**File: Z-8201**  
**Planner: Mike Corby**

| <b>SUBJECT:</b> | <b>APPLICATION BY: THE TRICAR GROUP<br/>1040 CORONATION DRIVE<br/>PUBLIC PARTICIPATION MEETING ON<br/>MARCH 4, 2014</b> |

Fig.2 Proposed Site Plan

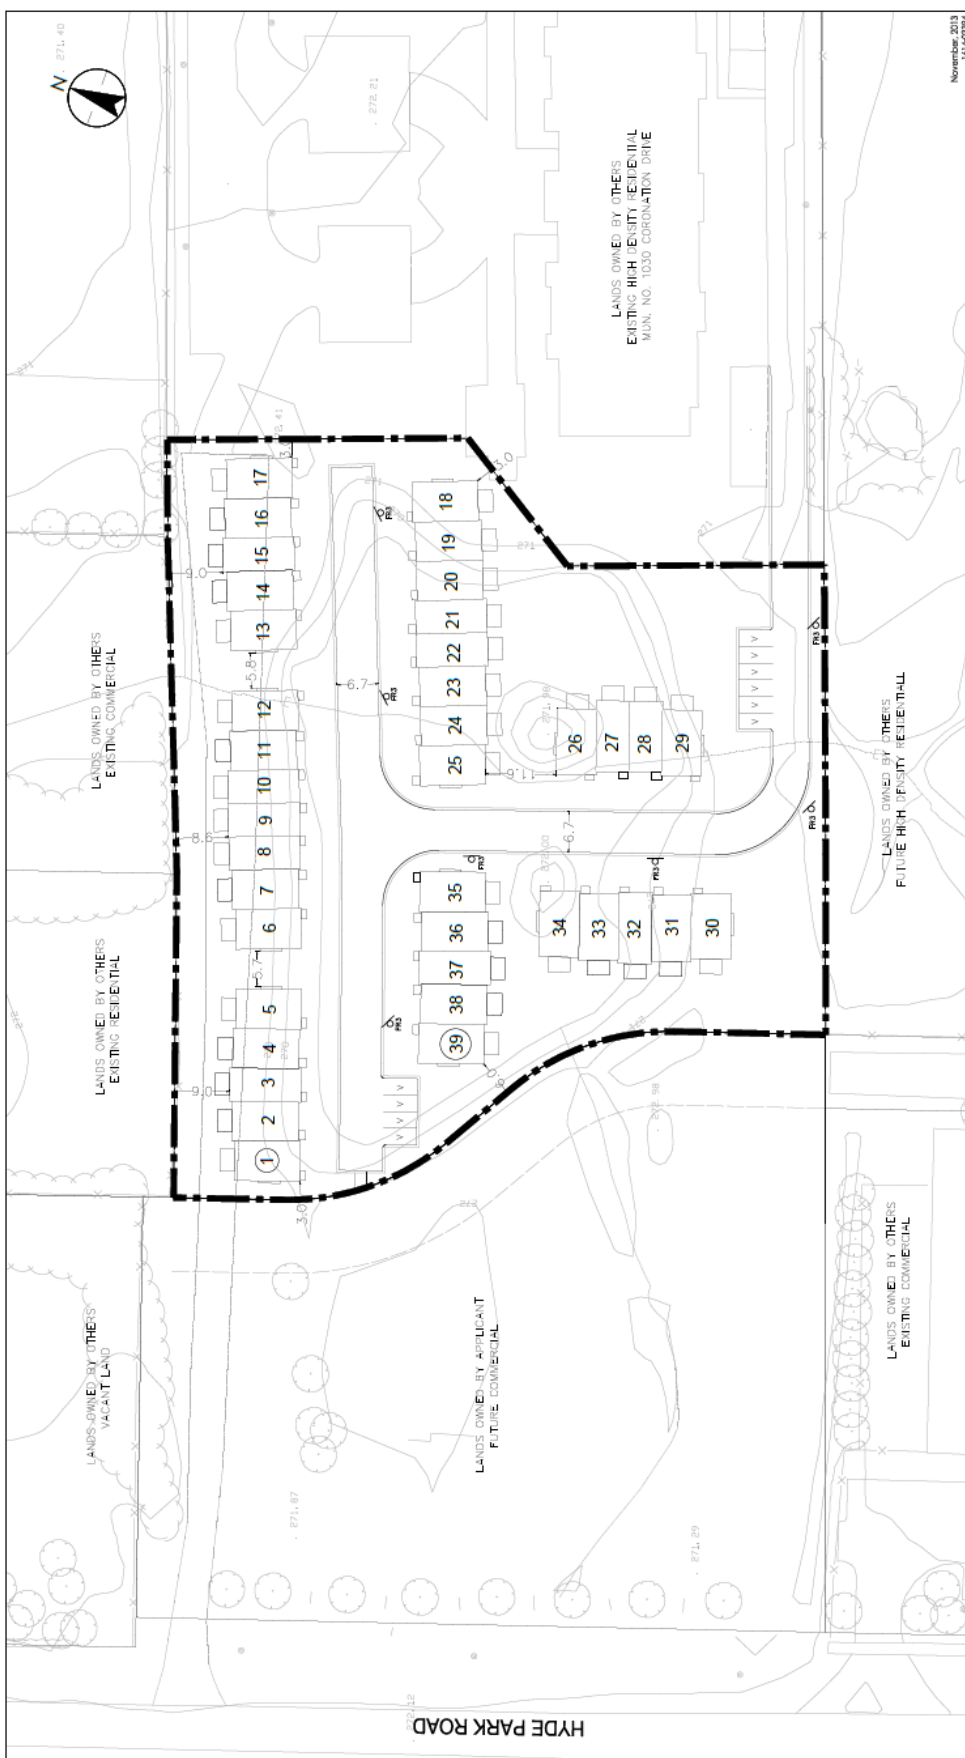
*Planning Staff is not supportive of the proposed site configuration and provide the following comments to consider while evaluating the proposal:*

- *Reconfigure the site to re-introduce the pedestrian spine that was originally contemplated between the high-rise buildings leading from Coronation Drive to Hyde Park Road.*
- *Ensure built form is located along and oriented towards the pedestrian spine in order to create an active edge, as well as to enhance the overall pedestrian experience through the site.*
- *Explore opportunities to consider an alternate form of housing, either low rise apartments, stacked towns or a combination of these forms with the proposed townhomes in order to increase the density of the site.*
- *Alterations to this site plan may be re-circulated to the Urban Design Peer Review Panel electronically for further advice on the revised design.*

- *The Panel noted that the concept of a public corridor is intriguing has not been captured in the current plan. Pedestrian connections to the existing apartment building to the east, and to Hyde Park Road to the west are paramount to the success of the development. The Applicant is encouraged to plan for these connections and strive for a higher level of pedestrian connections.*
- *It will also be necessary to provide for a vehicular connection to the access road to the west of the site that will be constructed in the future.*

- Consider introducing a node as a transition between the apartment site and the proposed townhome site.
- The board-on-board fence isolates the site and does not promote a sense of community. Ensure the fence indicated on the Landscape Plan between the proposed townhome development and the apartment building to the east is not included in future submissions to the City. Where required, consider a more subtle fence combined with plantings.

- The Applicant is encouraged to re-examine the layout of the proposed buildings to create more viable green space rather than the disparate pieces that are currently shown. The public/semipublic space does not need to be grandiose but should be more welcoming and inviting, with a higher level of design.

- Incorporate outdoor amenities such as a play area, community gathering spaces or a community garden. Further, Pedestrian paths throughout the site would provide an amenity for residents and connect the existing development with the proposed.

- Careful consideration is required for the end elevations of Units 29 and 30 as they are the gateway to the development.
- Consider paired driveways to afford opportunities for more substantial plantings to enhance the streetscape.

- Consider further exploration of building materials to better articulate the facades. In this regard, units that are shown with siding full height would benefit from some horizontal relief. Further, consider a consistent element, material or colour on all units to ensure a more cohesive development.

- (b) The Site Plan Approval Authority **BE REQUESTED** to implement the following design issues through the site plan process:
  - i) Placement of pedestrian connection through the site to connect with the proposed main street corridor on Hyde Park Road;

- ii) Consideration of a more subtle fence combined with plantings around the property to promote unity within the site and avoid isolation;
  - iii) Consideration of using building materials to better articulate the facades. In this regard, units that are shown with siding full height would benefit from some horizontal relief. Further, consider a consistent element, material or colour on all units to ensure a more cohesive development.

Fig.3 Revised Conceptual Site Plan

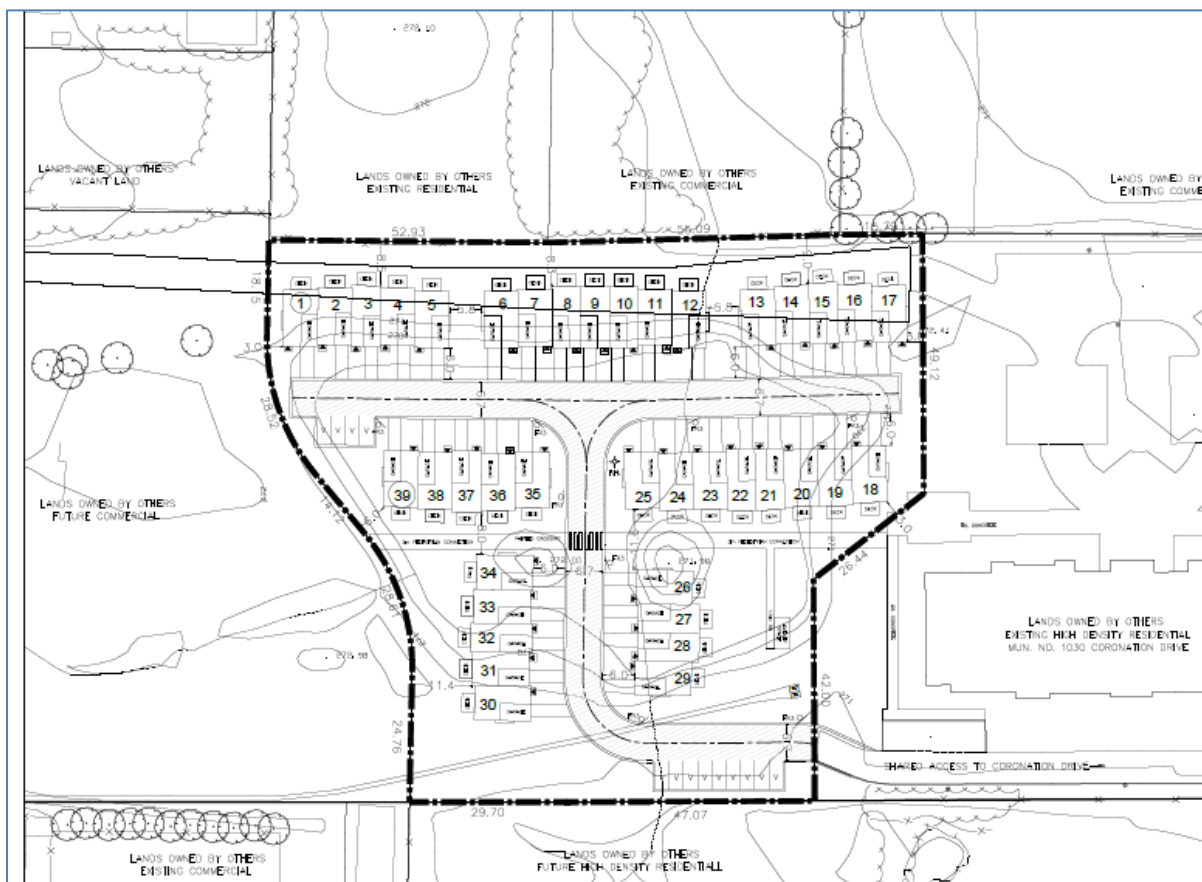
The key Urban Design issues raised include the re-introduction of the pedestrian spine and ensure built form is located along and oriented towards the pedestrian spine. The Applicant is also encouraged to plan for pedestrian connections to the existing apartment building to the

east, and to Hyde Park Road to the west to help create a transition between the apartment site and the proposed townhome site. The addition of a more viable green space and incorporating outdoor amenities such as a play area, community gathering spaces or a community garden can assist in the overall design and create that transition between properties. The proposed board-on-board fence isolates the site and does not promote a sense of community should be reconsidered. The idea of paired driveways can create opportunities for more substantial plantings to enhance the streetscape.
